ALTERNATIVES EVALUATION REPORT LOWER ALAMEDA CREEK/BART WEIR FISH PASSAGE ASSESSMENT

Flood Control &
Water Conservation
DISTRICT

December 14, 2006

B COMMITTEE REVIEW COMMENTS

Figure 1 – Extended Fish Ladder Alternative

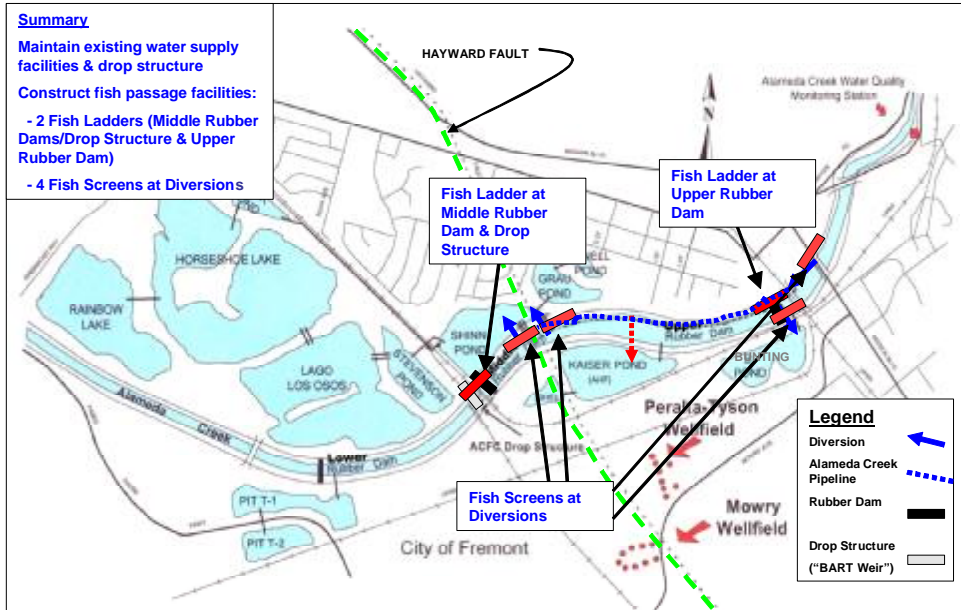
4. ACWD planning considerations for Middle Rubber Dam passage alternatives: ACWD is currently evaluating various alternatives for fish passage at the Middle Rubber Dam, including: (1) an extended fish ladder that provides passage past both the BART Weir and Middle Rubber Dam (see Figure 1, evaluated as the "Extended Vertical Slot" alternative in the draft BART Weir Passage report.); and (2) re-operating the Middle Rubber Dam such that it is deflated during the winter/spring migration period (see Figure 2, evaluated as the "roughened channel" and "reduced vertical slot" alternatives). The "re-operation" alternative

- a. Redundancy/reliability: The extended fish ladder alternative will provide ACWD with two operating rubber dams (and associated screened diversions) throughout the year. Given the proximity of Hayward Fault to these facilities, this is an important consideration for ACWD. With the potential failure of one dam, the other dam could still be utilized for water diversions through screened intakes. In addition, routine maintenance of ACWD's facilities above the Upper Rubber Dam (as well as other in-channel projects, such as the recent Mission Bridge project) may require that ACWD keep the Upper Rubber Dam deflated for a long period. Without the use of the Middle Rubber Dam and associated diversions (as considered under the re-operation alternative), this may have a significant impact on ACWD's water supplies.

- b. Operational flexibility: Maintaining two rubber dams operational throughout the winter and spring months (i.e. the extended fish ladder alternative) would also maintain existing operational flexibility for water supply operations. For instance, water could be supplied through screened diversions to the Quarry Lakes recharge pits via the Upper Dam, Middle Dam or both. In addition, maintaining the two rubber dams operational during the winter/spring would improve ACWD's capability to recharge water under high flow conditions. This operational flexibility may also provide benefits for fish passage. For instance, under certain conditions, a potential operating scenario after a high flow event may be to inflate the Middle Rubber Dam first, followed by inflating the Upper Rubber Dam at a later time. Under this operating scenario, a window of opportunity may be provided such that in-migrating steelhead would only need to pass through one fish passage facility in the flood control channel (the extended fishway), in order to access the upper watershed.

- c. Capital costs: Based on a recent study conducted by CH2M Hill (June 2006), the costs for ACWD passage facilities under the extended fish ladder alternative (fish ladders and screens) would be approximately \$2 million less than the cost of the pipelines and screens required for the re-operation scenario (assuming that ACWD and Flood Control evenly split the costs of the extended fish ladder, estimated at \$4.385 million - see comment #5 below). This does not include the operations and maintenance costs, which require further consideration.
